MSO9254A-01 S E R V I C E N O T E

MSO9254A 2.5GHz Mixed Signal Oscilloscope

Serial Numbers: MY49190101 and MY49190102

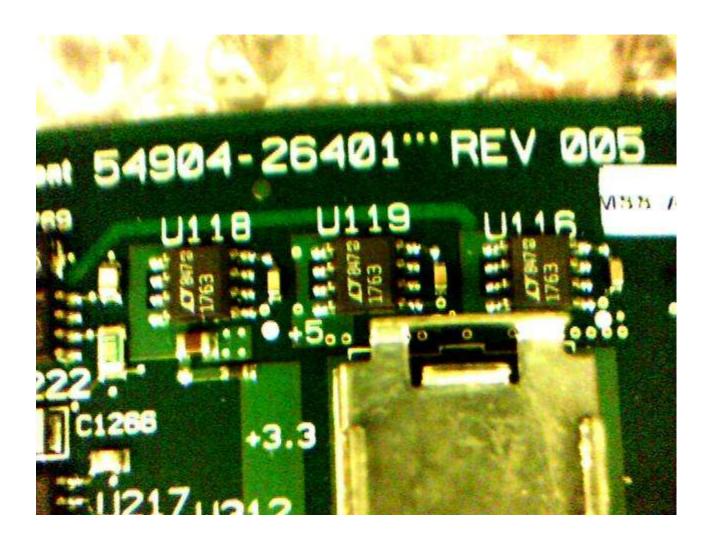
This is a onetime replacement because you are replacing the acquisition board 54901-66501 rev 005 with a later board rev of at least 006. The below picture shows a typical board number with the board rev listed. The board number 5490X-26401 is the raw PC board number. Once the board is loaded with parts and tested, the board number changes to 5490X-66501. The important part of the below picture is that the board rev of 005 is shown. This board must be removed from the scope and returned to SPO. SPO will return the defective board to AMC You can install a new or refurbished acquisition board in the scope. At the writing of this service note, the new board part number was 54902-66501 and the refurbished part number was 54902-69501. If the board rev is 006 or higher, do not replace the acquisition board with this service note.
